Apex House- Plymouth Grove

Pre- Commencement Planning conditions

Condition 9

Roscoe Comments – Provided 26th January 2026.

TYPICAL FLOW CONTROL CHAMBER
(SCALE 1:20)

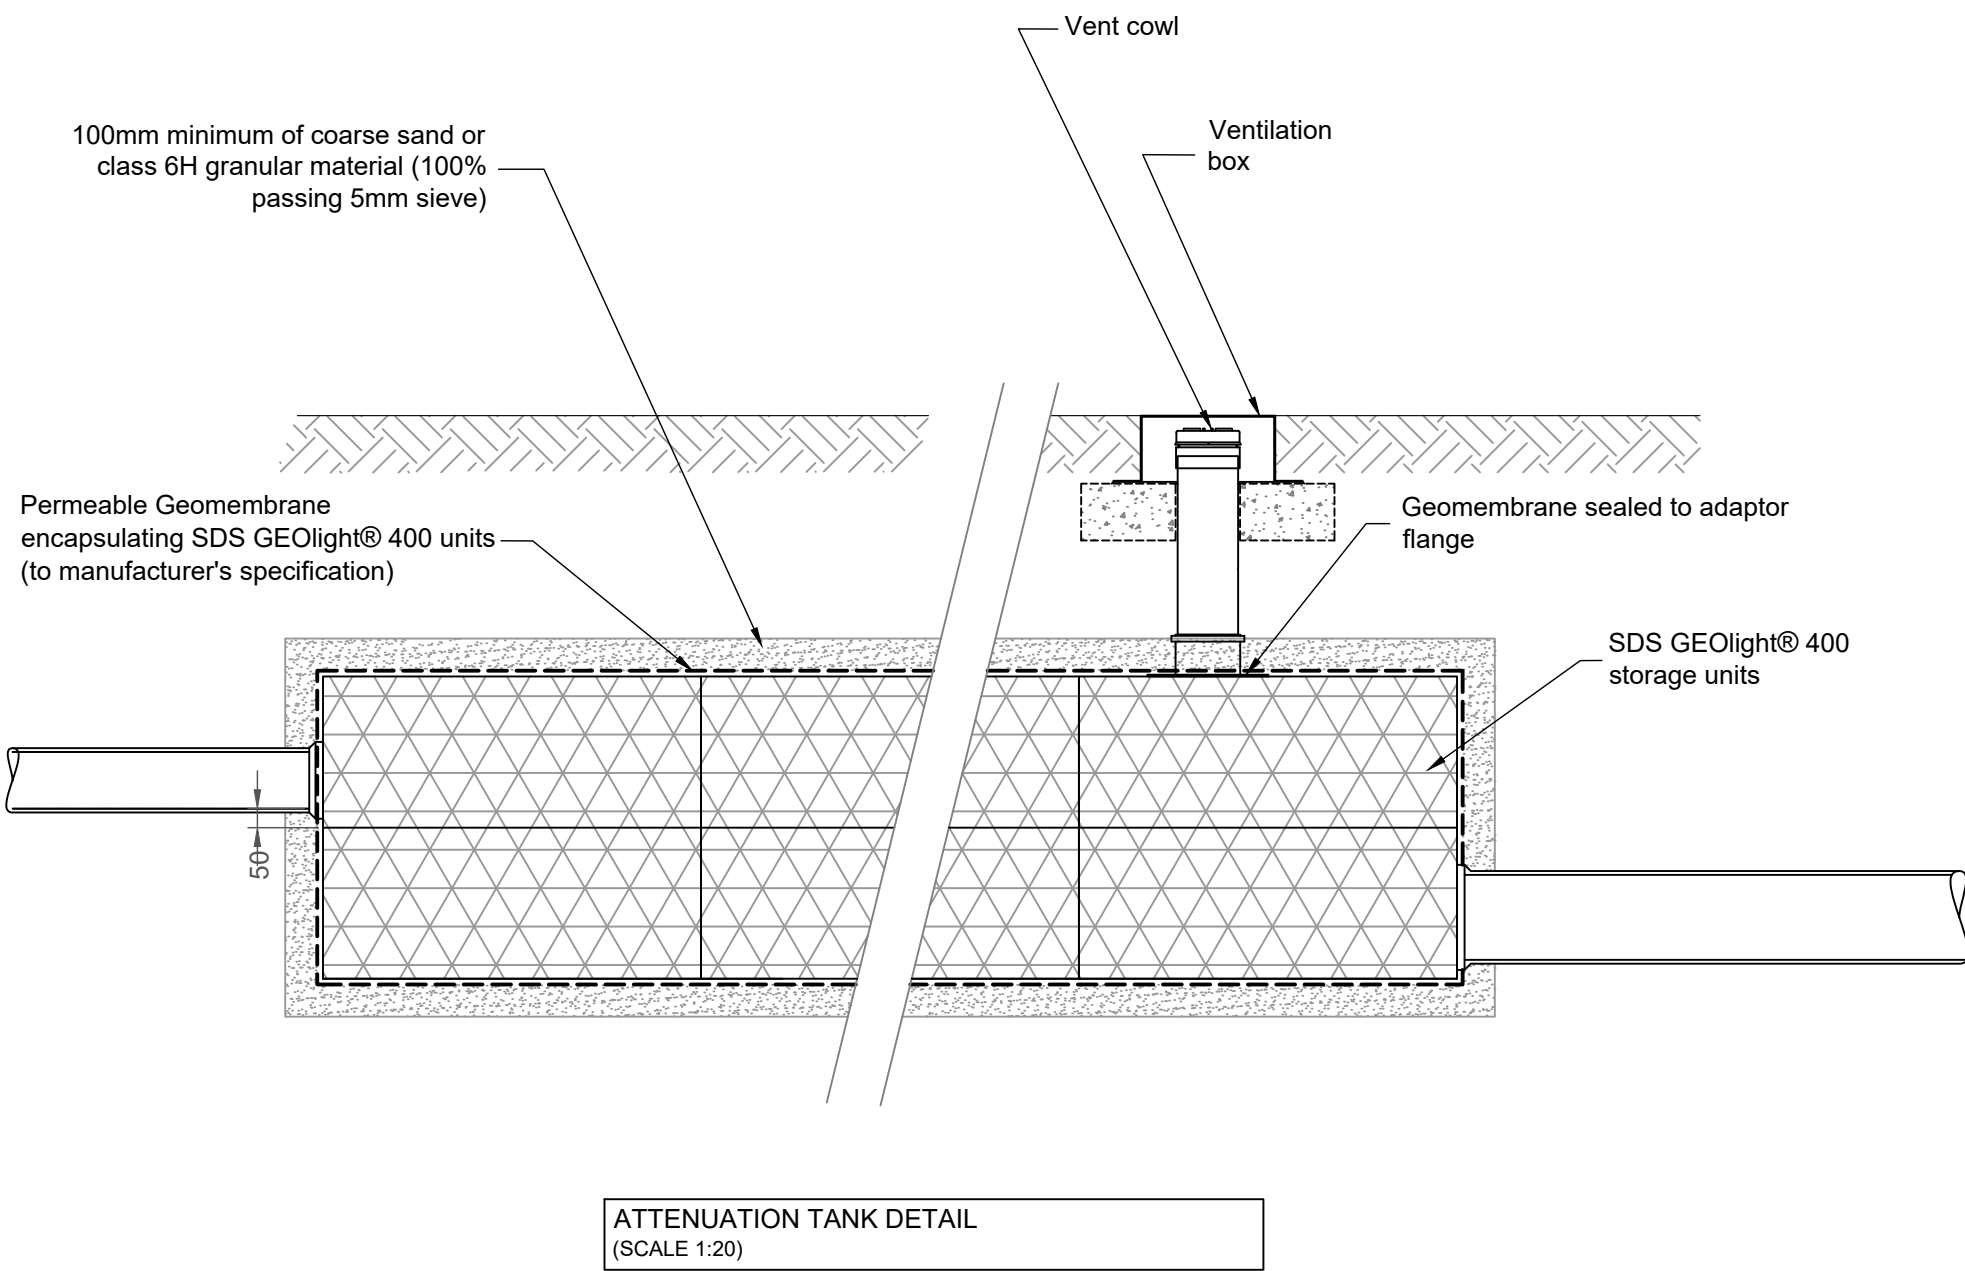
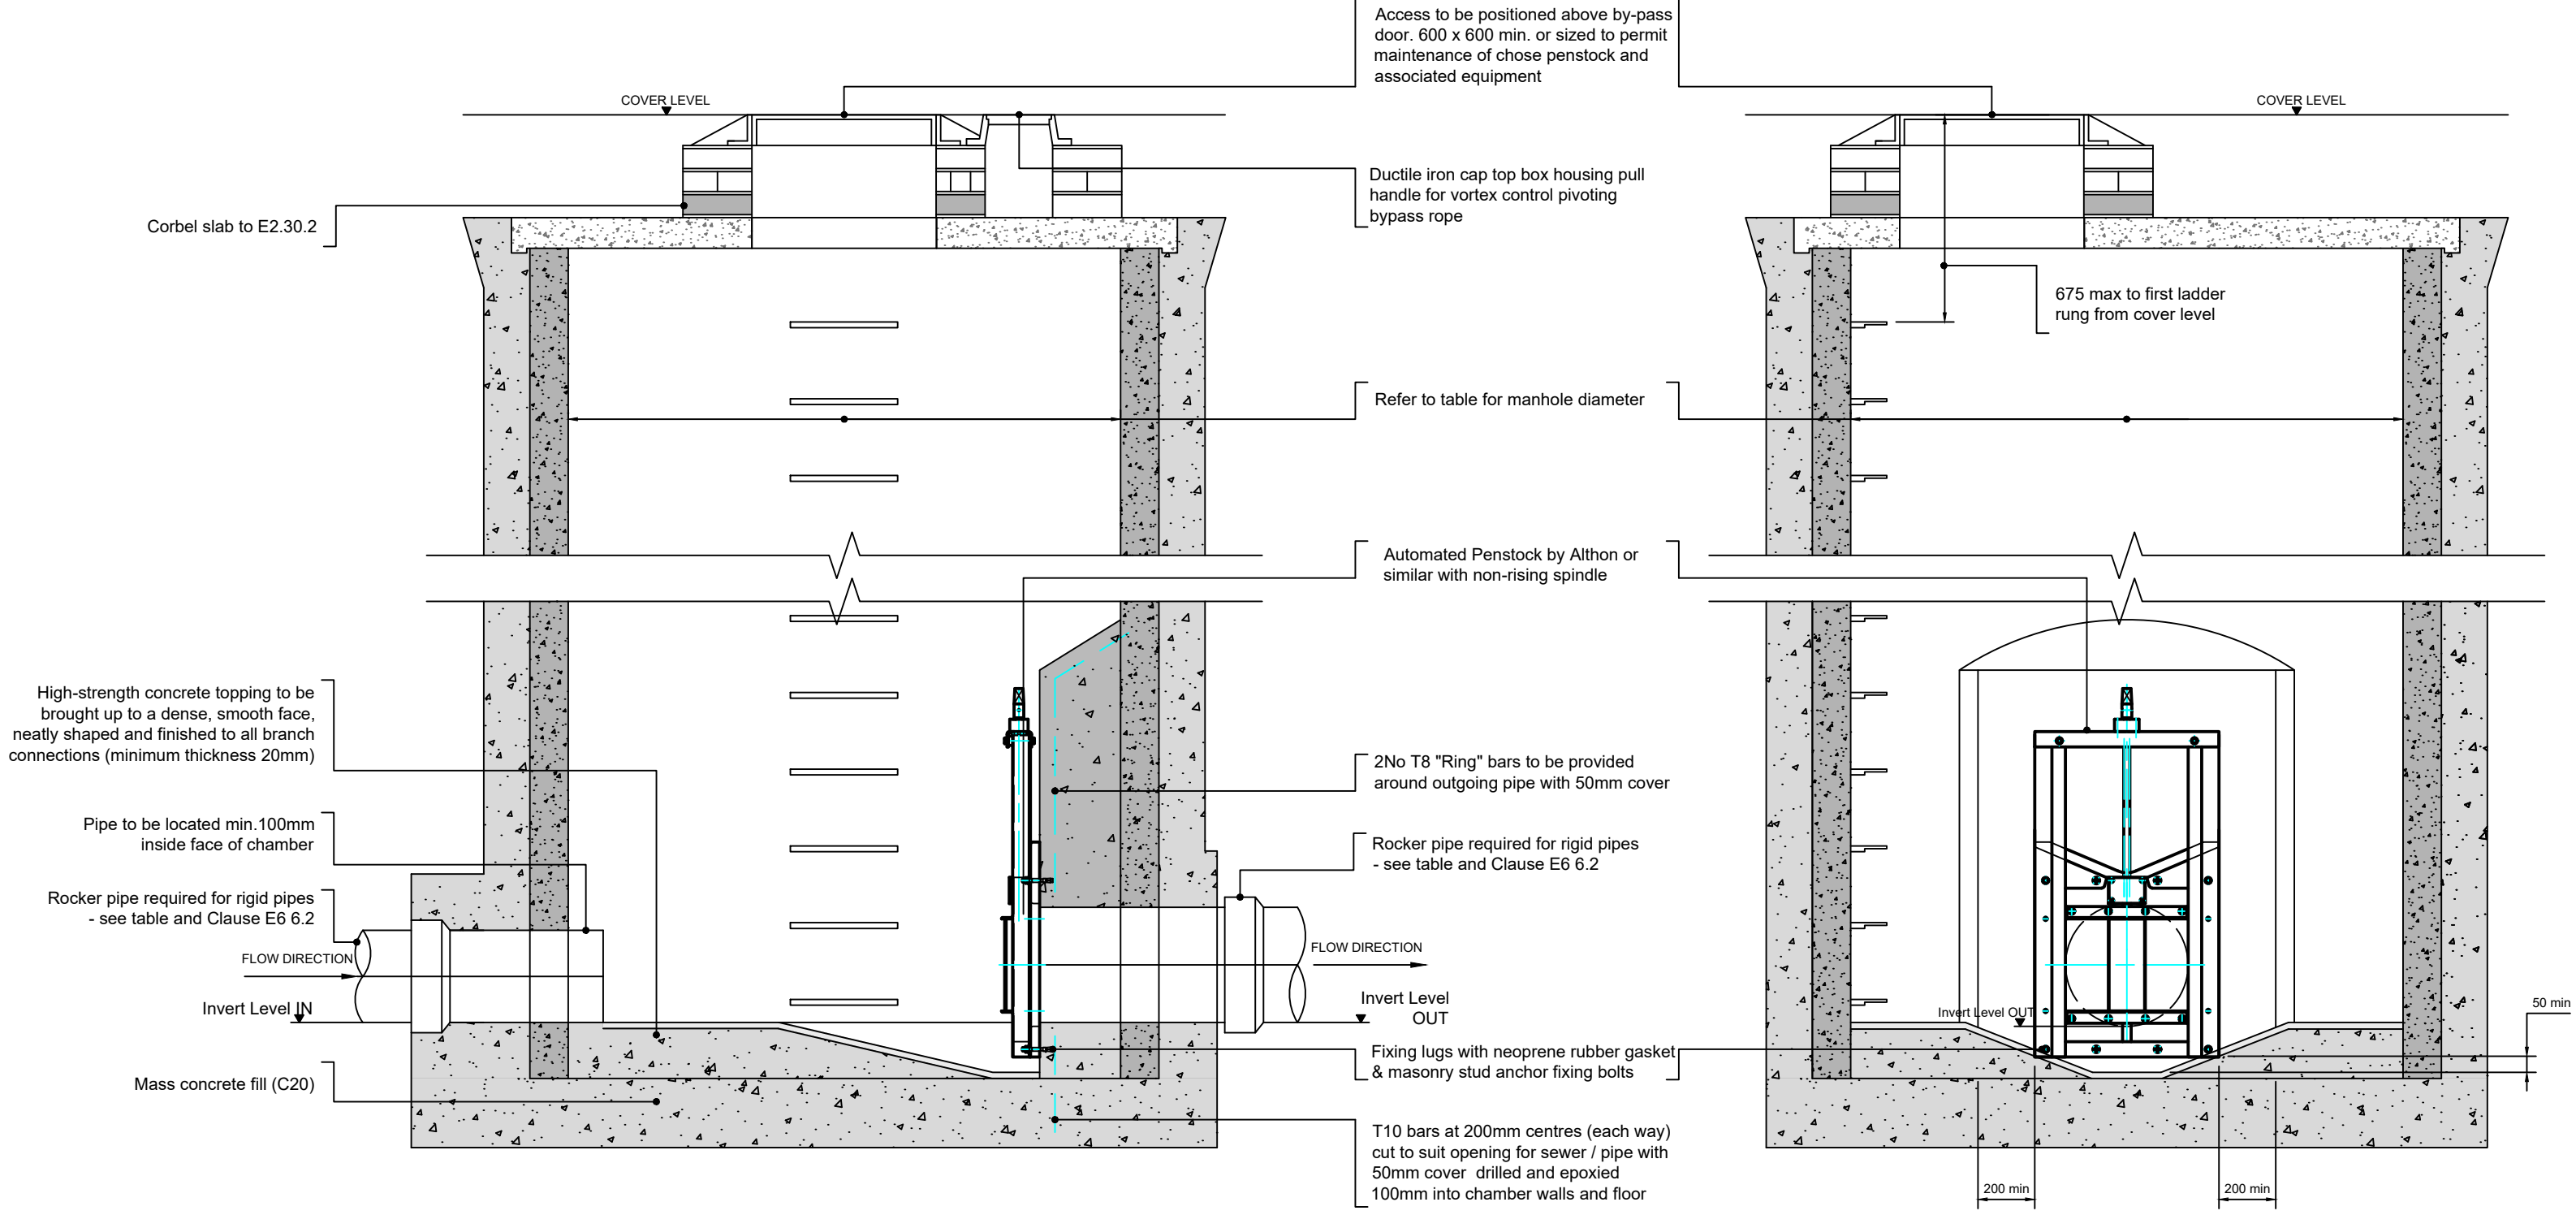
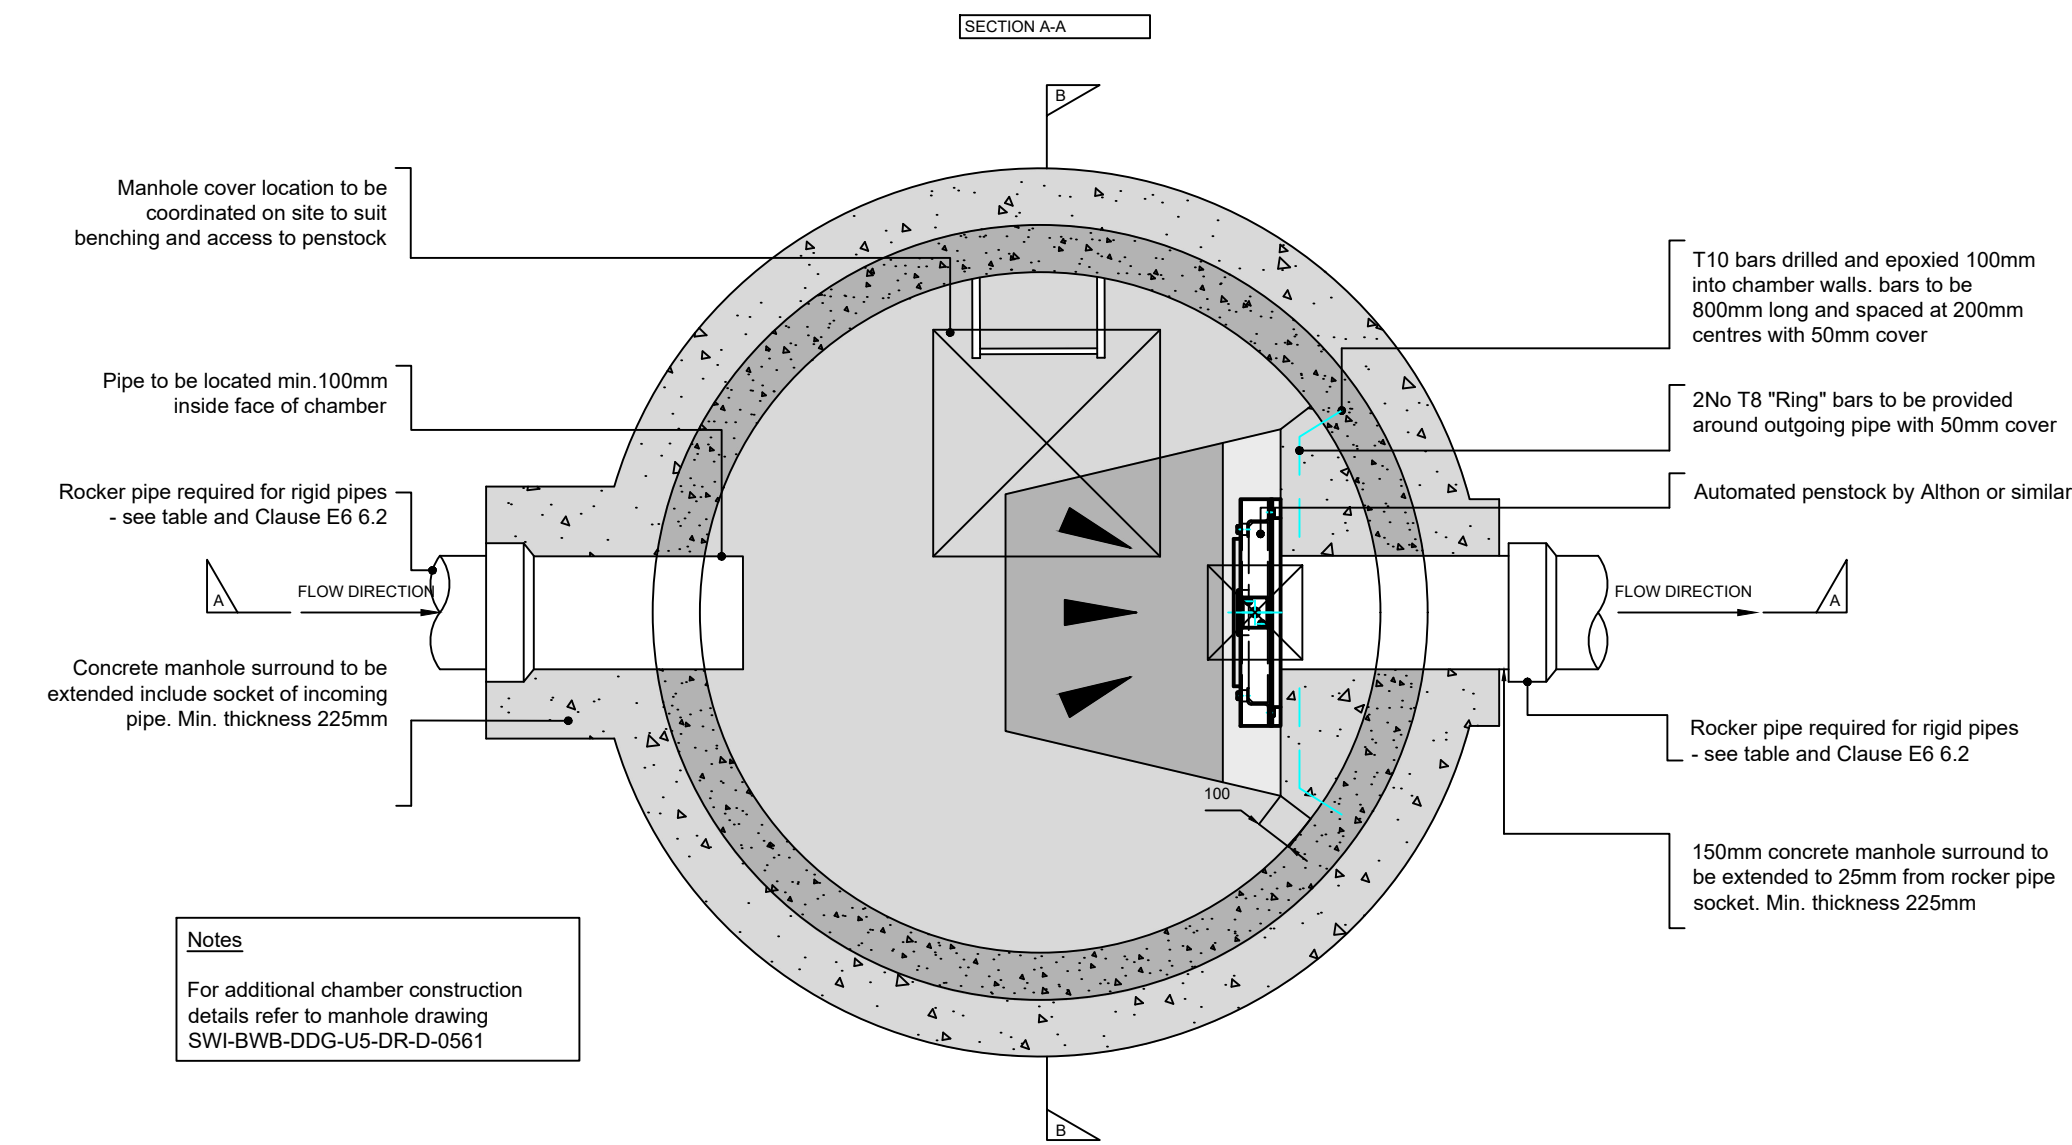
1. Construction details of flow control and SuDS elements.

Drainage details have been attached in Appendix E.
